SEWAGE DISPOSAL SYSTEM

MARYLAND STATE DEPARTMENT OF HEALTH

HOWARD COUNTY

SUBDIVISION River Park Estates

Scale: 1" = 50'

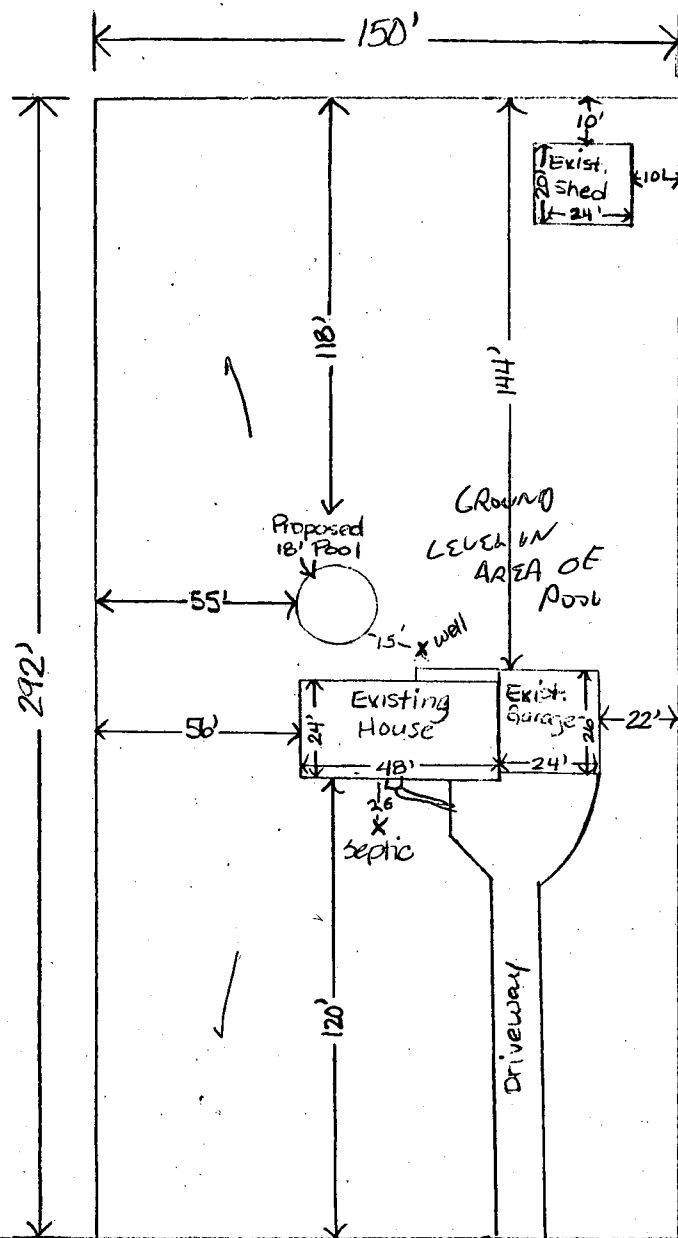
BRI SEPTIC CLEANOUT IS UNDER YARD ORNAMENT IN FRONT OF HOUSE

WELL IS BURIED - owner SAYS NO PIT, 18' FROM HOUSE, 7' FROM PORCH

PROPOSED POOL IS NO CLOSER TO WELL THAN

EXISTING HOUSE SEPTIC TANK OK TO PROCEED
